Detailed Site Plan Alternative Compliance Branchville Gardens

DSP-19042
AC-19025

SUBJECT: Detailed Site Plan DSP-19042
Type 2 Tree Conservation Plan TCP2-012-2020
Branchville Gardens

Figure 4: Permanent real estate sign

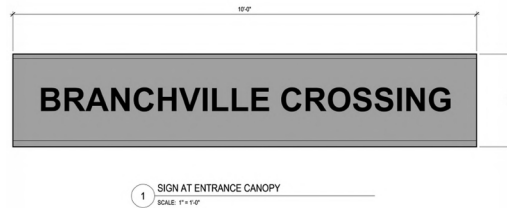
One building-mounted sign is shown above the main entrance to the building, and a detail has been provided by the applicant. The applicant states that this is a permanent real estate sign and meets the regulations of Section 27-618(c) of the Prince George’s County Zoning Ordinance.

A signage area schedule has not been provided listing the square footage of the proposed signage. Therefore, a condition has been included in the Recommendation section of this report, requiring that a signage schedule be provided.

- d. Provide a schedule clearly indicating the area of the proposed freestanding and building-mounted signage in conformance with Sections 27-614 and 27-618 of the Prince George's County Zoning Ordinance.

Concern #1 – Adequate turning radius for apparatus departing our station

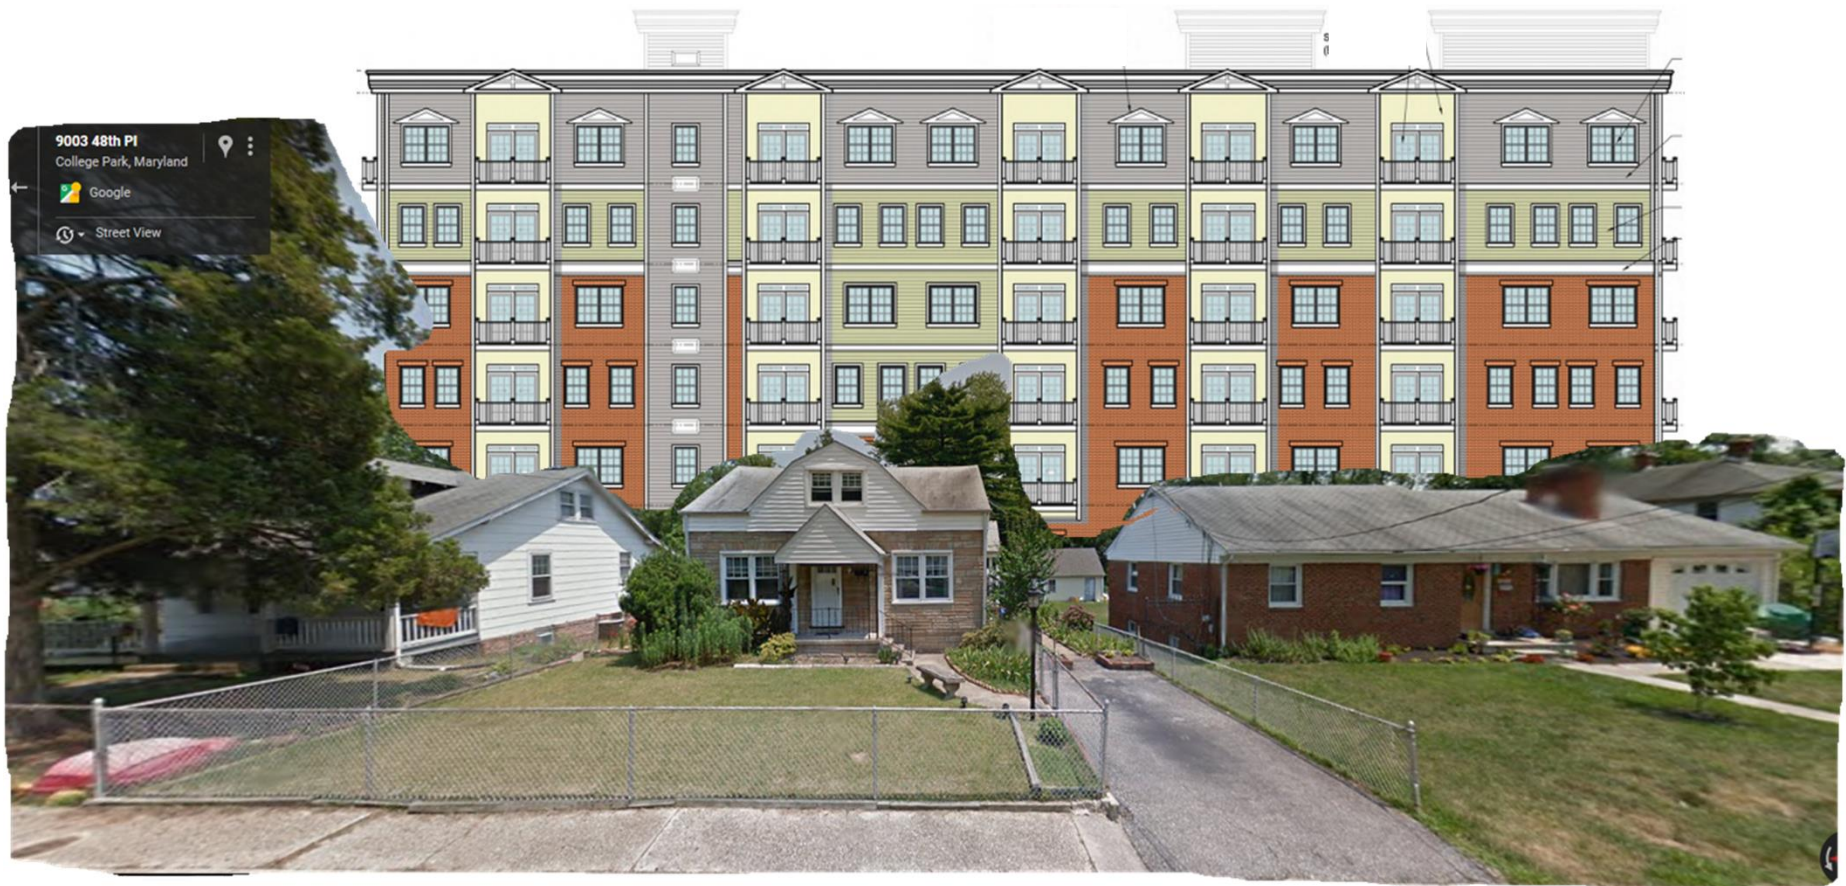
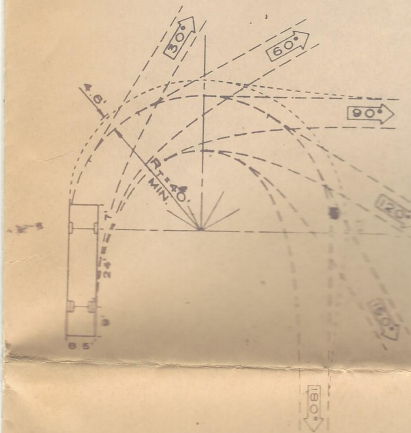
Branchville Vol. Fire Co. feels the project is too large for the lot, the size of the structure is not in keeping with the character of the neighborhood, and we have safety concerns.

- Width of Bay Door = 10 feet
- Apparatus Width = 8 feet (body), 9' 4" (mirror to mirror)
- Apparatus Length = 30 feet
- Front ramp of station = 12 feet (wall to curb)
- Branchville Road = 26 feet curb to curb
- Adequate turning radius was condition of 1988 Cruz DSP approval and Cruz incorporated guidance from PGFD to provide 45 foot radius recommended on site plan
 - Cruz providing asphalt pavement north of Branchville Road to their southern property line in front of our engine bays, adequate but not the 45' radius recommended and no room for any unit larger than what we have already
- FYI - Backing into station harder than pulling out!

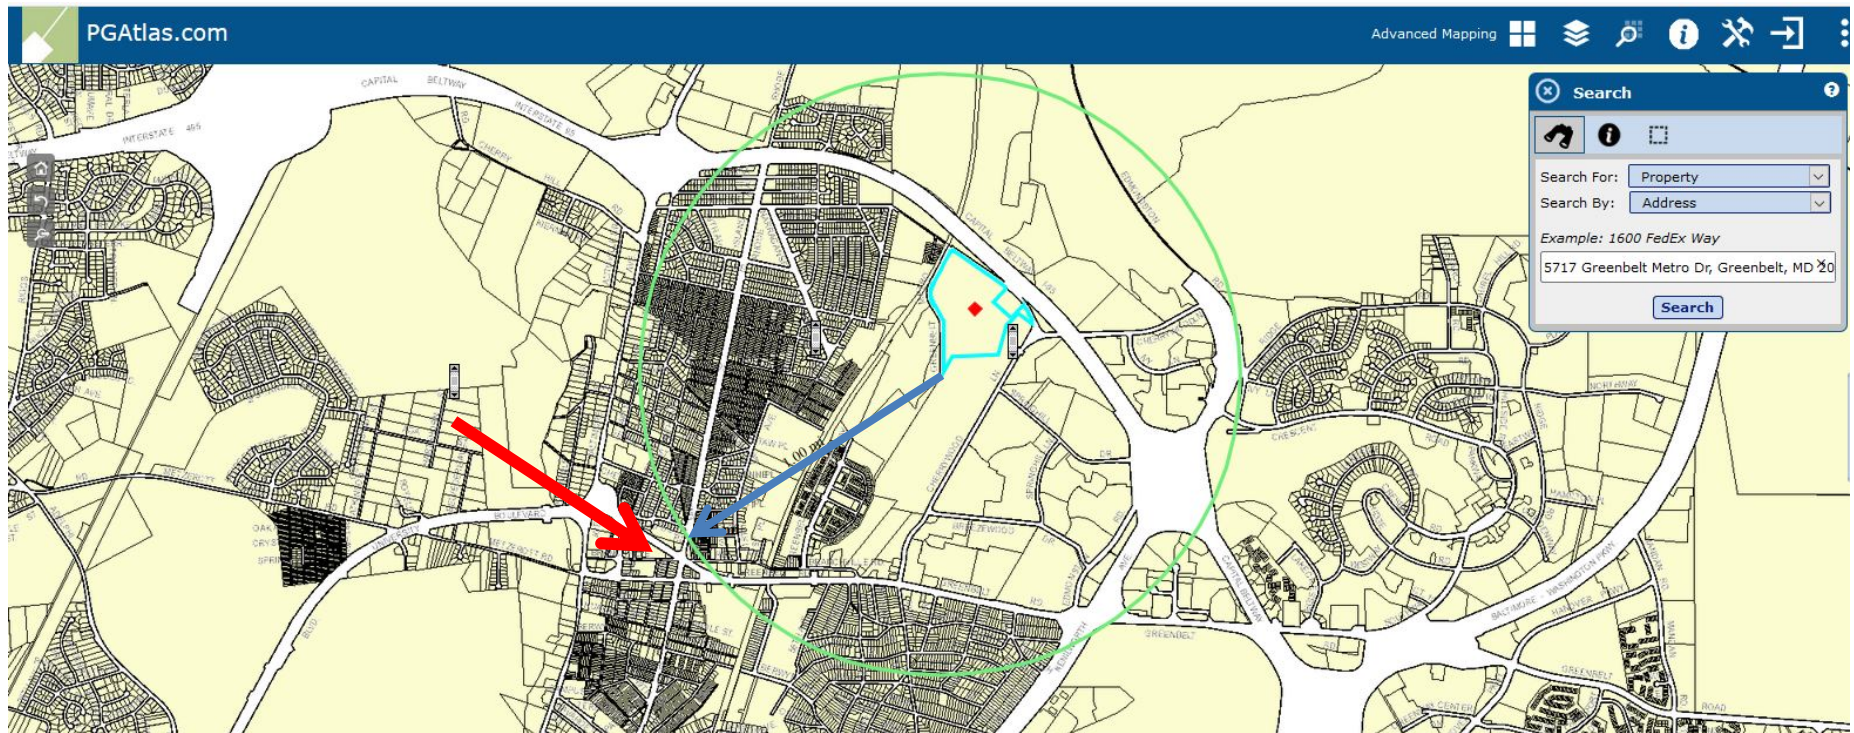
The center of the red circle is the southern point of a WMATA property that serves as part of the stormwater management system at Greenbelt Metro Station, the center of the green circle is the west entrance to Greenbelt Station. WMATA also has track ROW going top to bottom through the middle of the page - that isn't counted, correct?

Note, using points of origin already defined in code and shown in green, the Cruz property is neither touching or wholly within one-mile radius and so the project should be required to provide the full parking requirements of Sec. 27-568.
